# UNITED STATES PATENT AND TRADEMARK OFFICE

APPLICATION NO.	FILING DATE	FIRST NAMED INVENTOR	ATTORNEY DOCKET NO.	CONFIRMATION NO.
09/677,870	10/03/2000	Woo Hyuk Choi	2658-0240P	6124
2292	7590	01/26/2006	EXAMINER	
BIRCH STEWART KOLASCH & BIRCH			RUDE, TIMOTHY L	
PO BOX 747			ART UNIT	
FALLS CHURCH, VA 22040-0747			PAPER NUMBER	
			2883

<b>Office Action Summary</b>	<b>Application No.</b>		<b>Applicant(s)</b>	
	09/677,870		CHOI ET AL.	
	<b>Examiner</b>		<b>Art Unit</b>	
	Timothy L. Rude		2883

## DETAILED ACTION

**FIG. 19A**

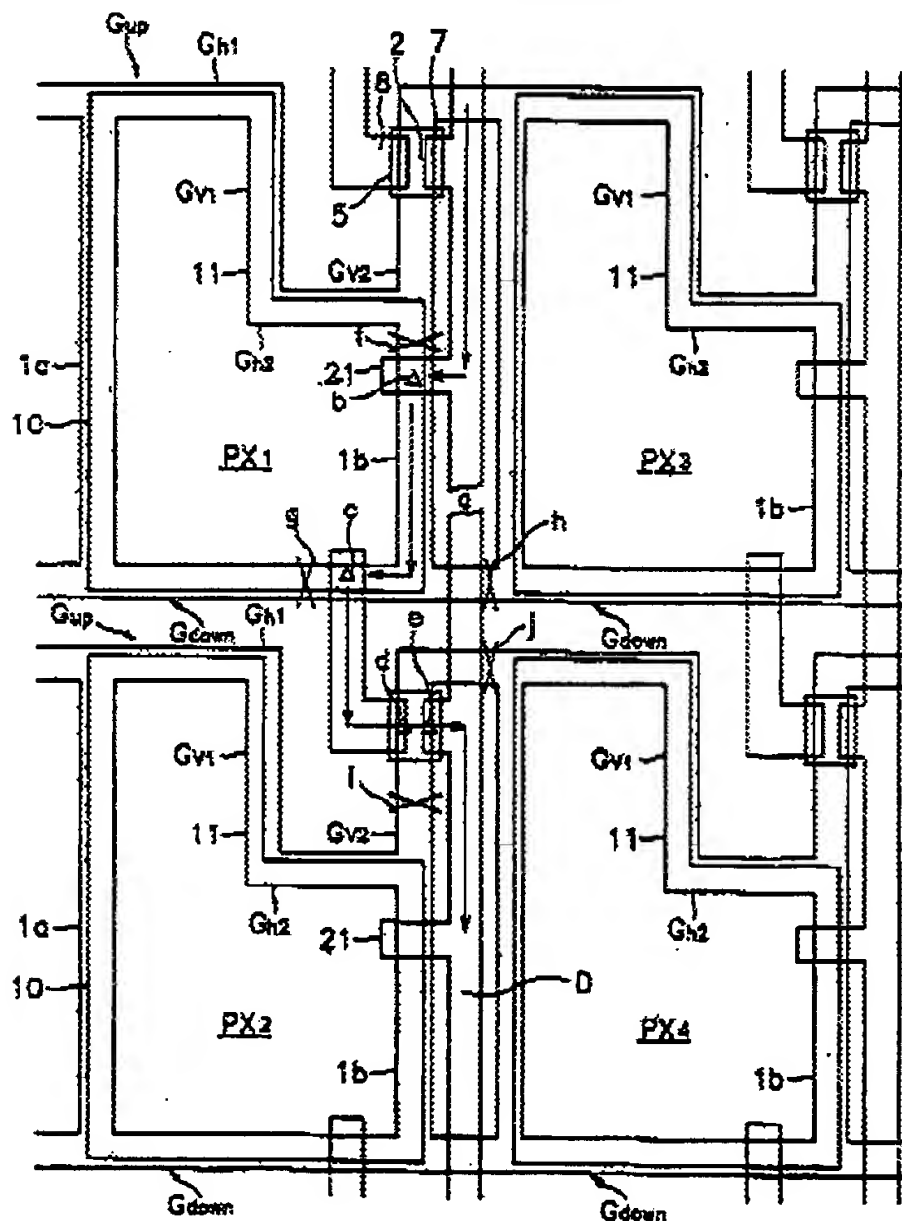
Song teaches 1) the use of a redundant pattern that is integrated with the gate line in Figure 19A ( $G_{up}$  and  $G_{down}$  or 1a and 1b) as a redundancy electrode for electrically connecting the gate line to the broken data line (col. 17, lines 4-67, especially col. 17, lines 47-54) to effect repairs.

Song is evidence that ordinary workers in the art of liquid crystals would find the reason, suggestion, or motivation to form the gate dummy pattern in such a manner as

to serve as a redundancy electrode for electrically connecting the gate line to the broken data line to effect repairs.

Therefore, it would have been obvious to one having ordinary skill in the art of liquid crystals at the time the invention was made to modify the LCD of Kim with the redundancy electrodes for electrically connecting the gate line to the broken data line per Song.

*FIG. 13*

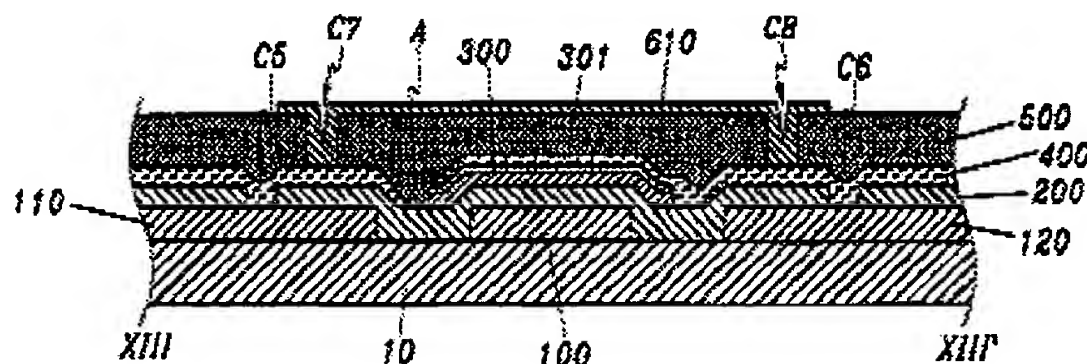
Kim teaches in Figure 13 wherein when the data line is broken, the use of forming holes and connections to the repair lines, 110 and 120, (Applicant's gate dummy pattern) and to a connecting pattern, 610, to repair a broken data line, 400, (col. 8, lines 1-15).

**FIG. 26**

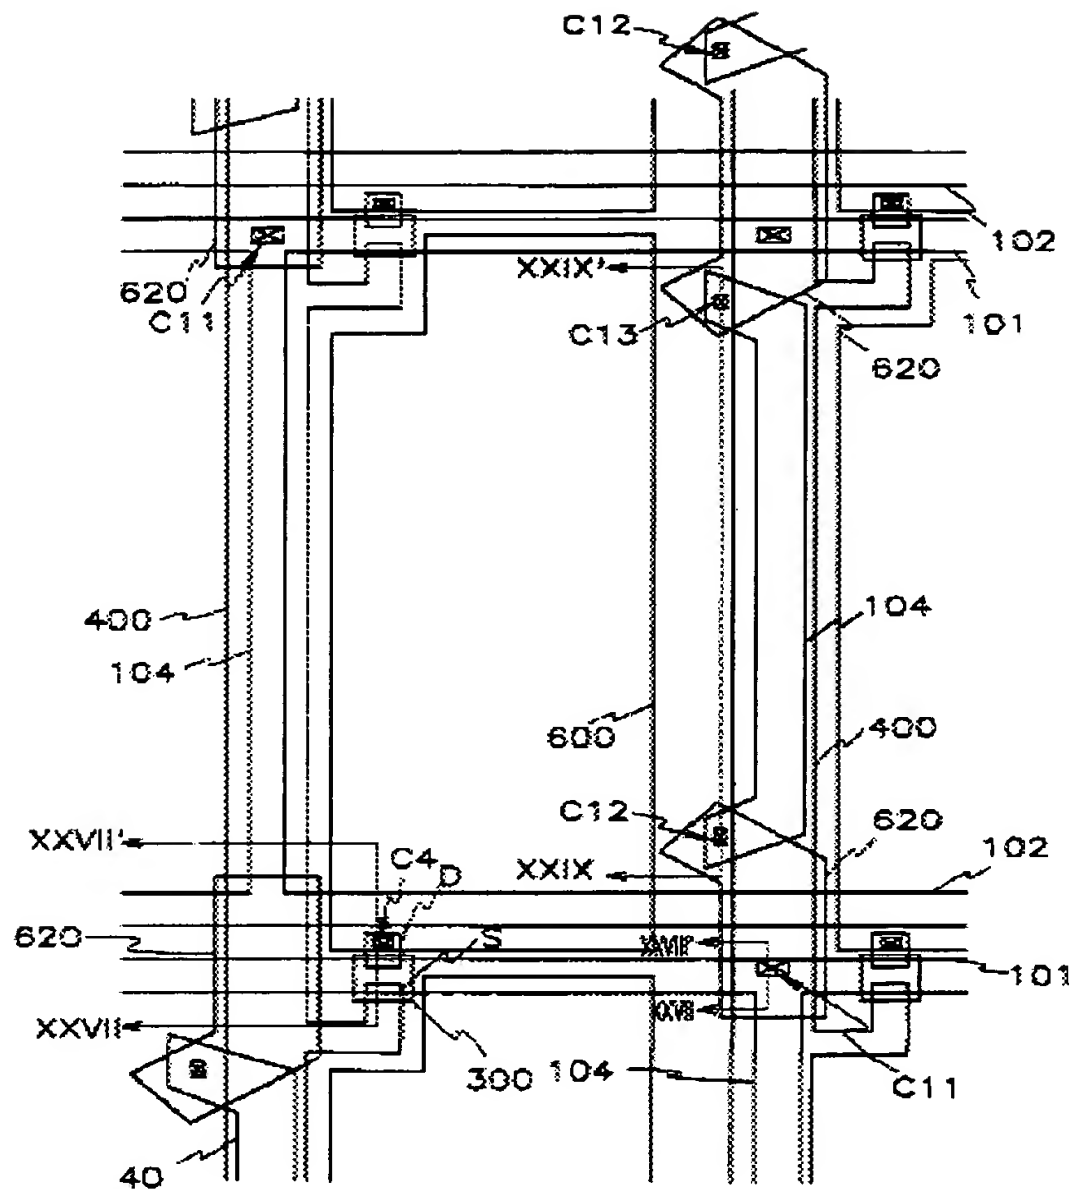
Kim teaches in Figure 26 the use of repair lines, 104, (Applicant's gate dummy pattern used as a redundancy electrode) to connect the gate line to the data line (col. 13, lines 4-17).

Kim is evidence that ordinary workers in the art of liquid crystals would find the reason, suggestion, or motivation to form holes and connect gate dummy patterns to gate lines to repair a broken data line.

Therefore, it would have been obvious to one having ordinary skill in the art of liquid crystals at the time the invention was made to modify the LCD of Kim by forming holes and connecting gate dummy patterns to gate lines to repair a broken data line.

**FIG. 19A**

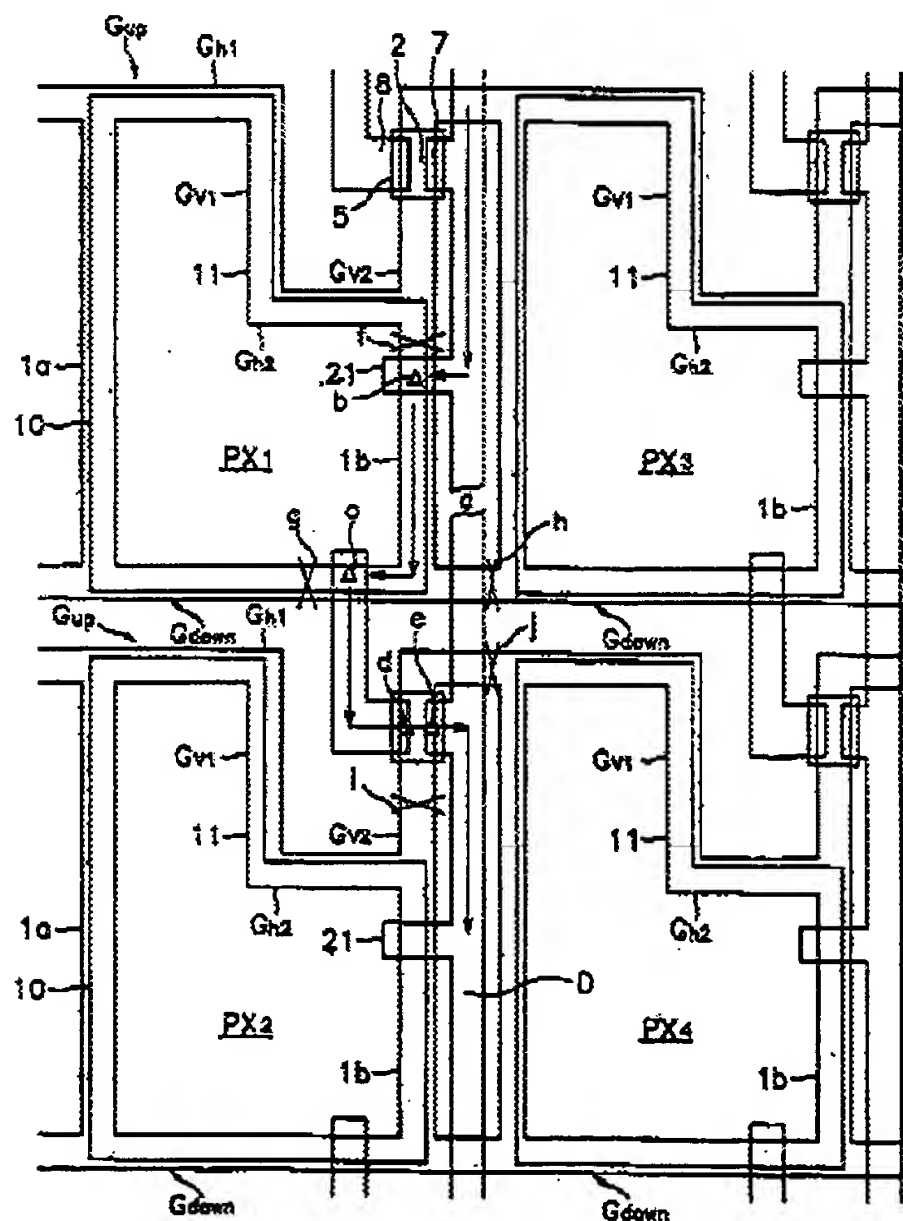
Song teaches, wherein when the data line is broken, the use of a redundant pattern in Figure 19A ( $G_{up}$  and  $G_{down}$  or 1a and 1b) as a redundancy electrode for electrically connecting the broken data line (col. 17, lines 4-67, especially col. 17, lines 47-54) to effect repairs.

Song is evidence that ordinary workers in the art of liquid crystals would find the reason, suggestion, or motivation to form the gate dummy pattern in such a manner as to serve as a redundancy electrode for electrically connecting the gate line to the broken data line to effect repairs.

Therefore, it would have been obvious to one having ordinary skill in the art of liquid crystals at the time the invention was made to modify the LCD of Kim with the redundancy electrodes for electrically connecting the gate line to the broken data line per Song.

**FIG. 18**

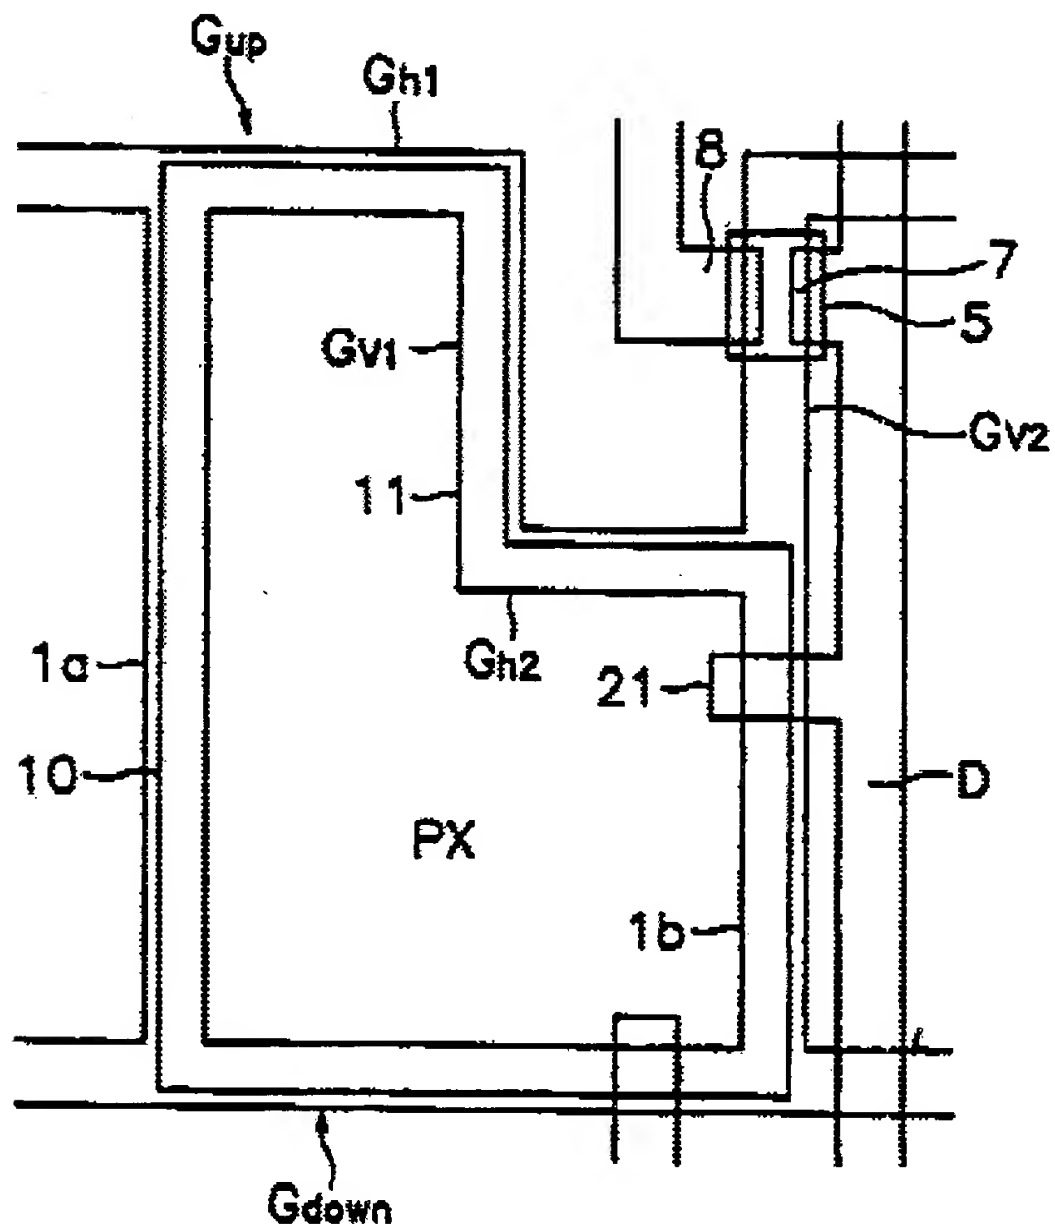
As to claims 6, 15, 22, and 24, and Song teaches in Figure 18 a thin film transistor substrate further comprising: a storage capacitor (col. 15, lines 56-64) defined by a horizontal overlapping part,  $G_{h2}$ , between the gate line and the pixel electrode, PX. Song also teaches in Figure 18 an analogous overlapping portion, 21, of the data line, D, to permit a repair. Also, any two conductors separated by an insulator result in a capacitor as a matter of physics. Therefore the overlap region between the pixel electrode and the dummy pattern which are separated by an insulator necessarily forms a capacitor.

As to claims 7 and 16, Song teaches in Figures 18 and 19A a protrusion, 21, protruded from the data line in such a manner to overlap with the intended repair site (Applicant's recess and narrowed portion of the gate dummy patterns), the structure of which would thereby shut off a light leaked between the gate dummy pattern and the gate line (col. 15, lines 42-63). Note that in considering the disclosure of a reference, it

Song is evidence that ordinary workers in the art of liquid crystals would find the reason, suggestion, or motivation to add a protrusion in the data line, formed in such a manner to overlap with the area of the recess and narrowed portion of the gate dummy patterns, to permit a repair.

Therefore, it would have been obvious to one having ordinary skill in the art of liquid crystals at the time the invention was made to modify the LCD of Kim with the protrusion of Song to permit a repair.

**Fig.2 PRIOR ART**

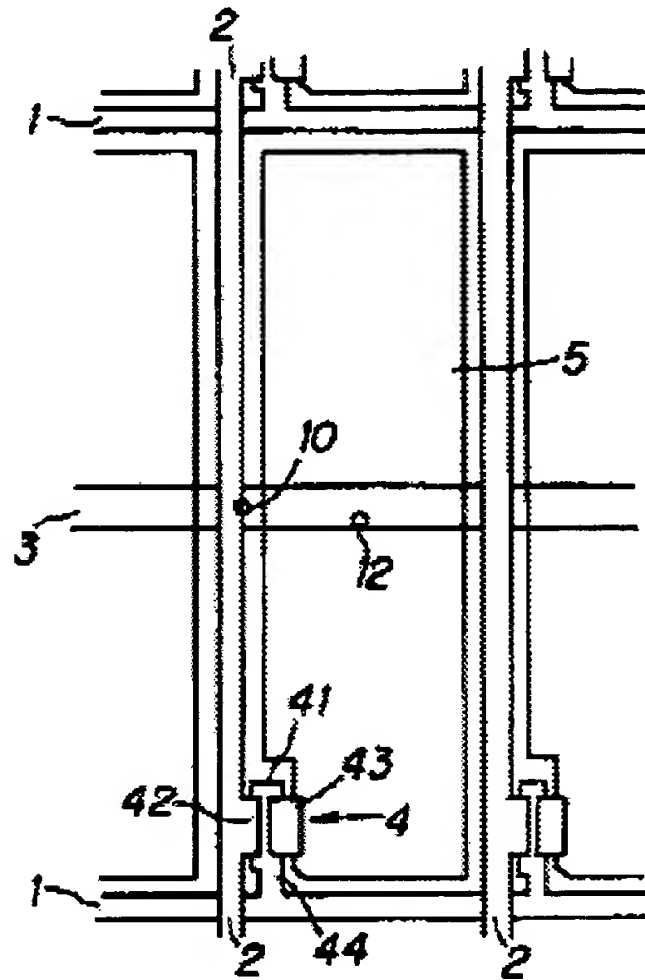
(5) Applicant's cannot find a recess in Figure 2, so the combination would not have a protrusion over the recess and would be inoperable.

(5) It is respectfully pointed that recess is on the left side of the narrow part, 44, that leads to the gate electrode, 41, in Figure 2 below:

The teaching of Irie would be more than sufficient to render the use of a recess obvious to one having ordinary skill in the art at the time the claimed invention was made, and as evidenced by the prior art, would not be confusing with respect to the need for light blocking layers (no teaching away). One skilled in the art does not forget fundamentals (like light blocking) when incorporating an added feature (like a recess/narrowed portion). Examiner cannot see any reason to believe one of ordinary skill in the art would be mislead into creating an inoperable device based upon the combination of applied prior art.
